**TRANSPORT COLORADO  
FDP DRAINAGE LETTER  
SUB-AREA 1**

## Drainage Conformance Letter

### Subject: Sub-Area 1\_ Framework Development Plan

**TRANSPORT COLORADO**  
**PUBLIC IMPROVEMENT PLAN**  
**SUB-AREA 1**

FIG 1: VICINITY MAP

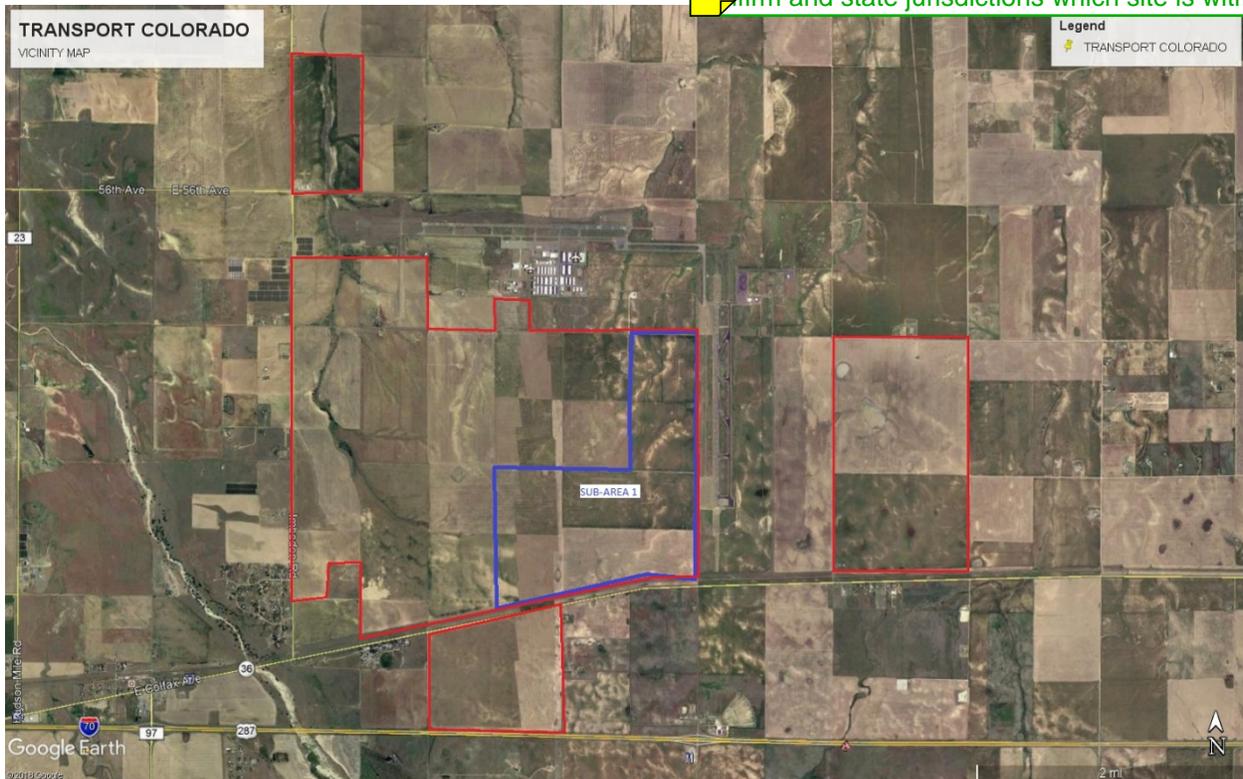
Appears Sub-Area 1 is entirely within COA - please firm and state jurisdictions which site is within.

SIX LANE MAJOR ARTERIAL - HALF STREET IMPROVEMENT (S1.4)

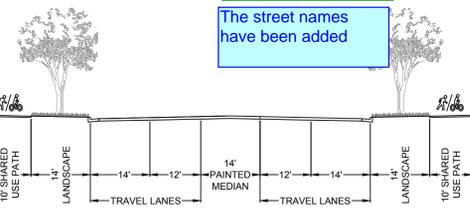
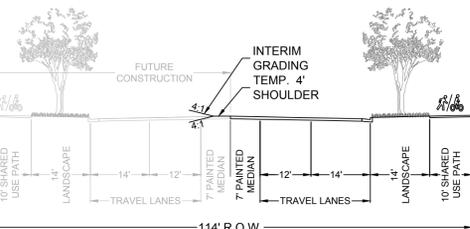
Add street names to the relevant sections

The street names have been added

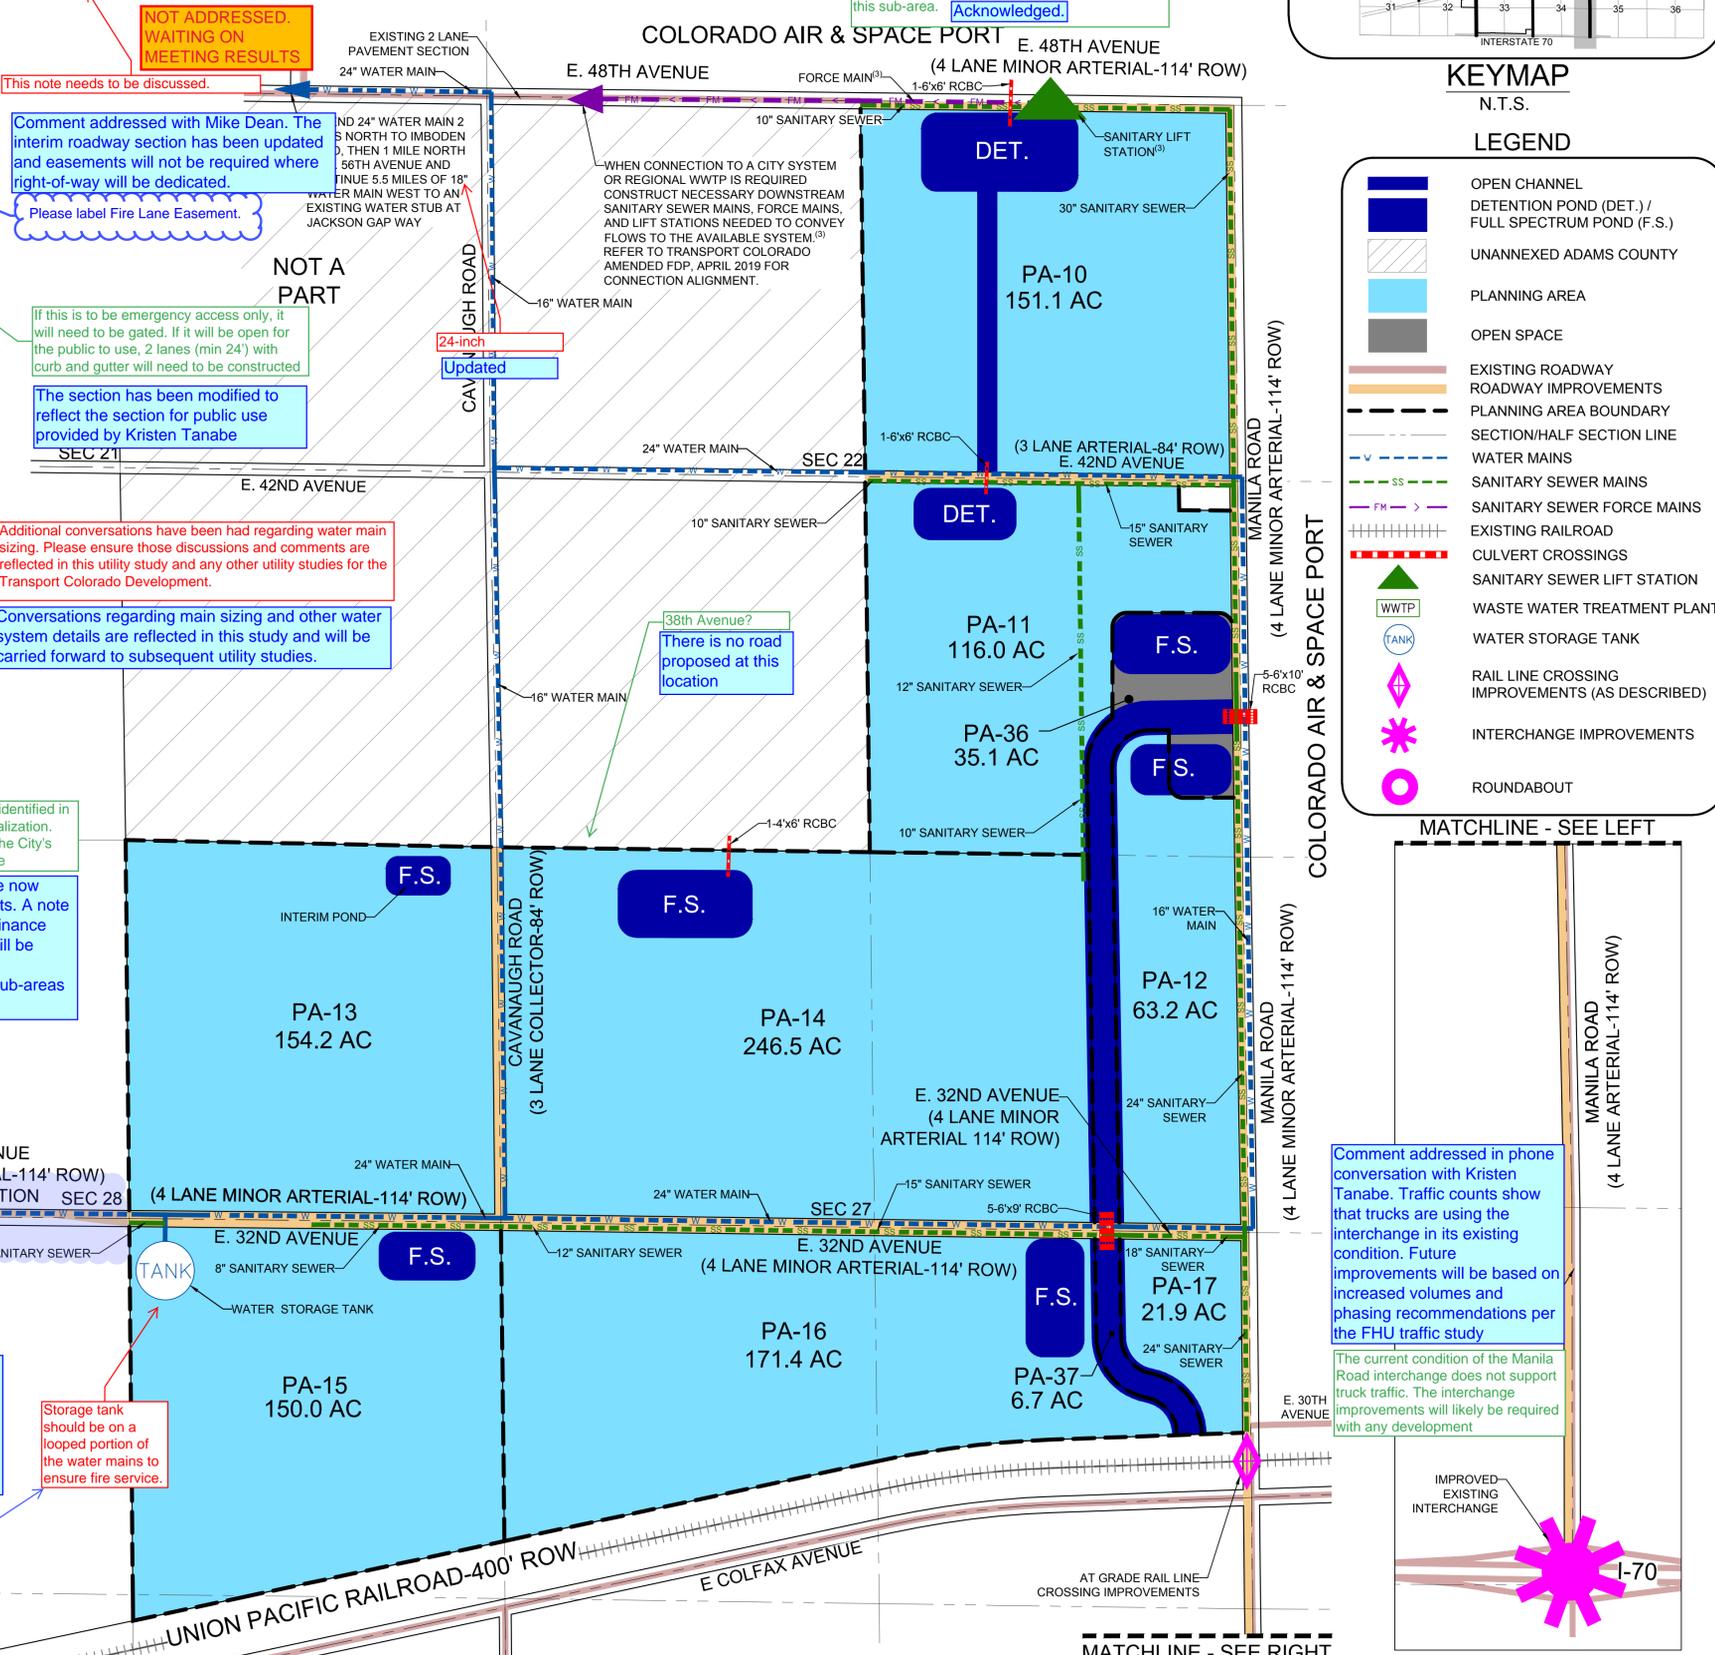
Storage tank should be on a looped portion of the water mains to ensure fire service.

Fire/Life Safety concurs.

NOT ADDRESSED. WAITING ON MEETING RESULTS
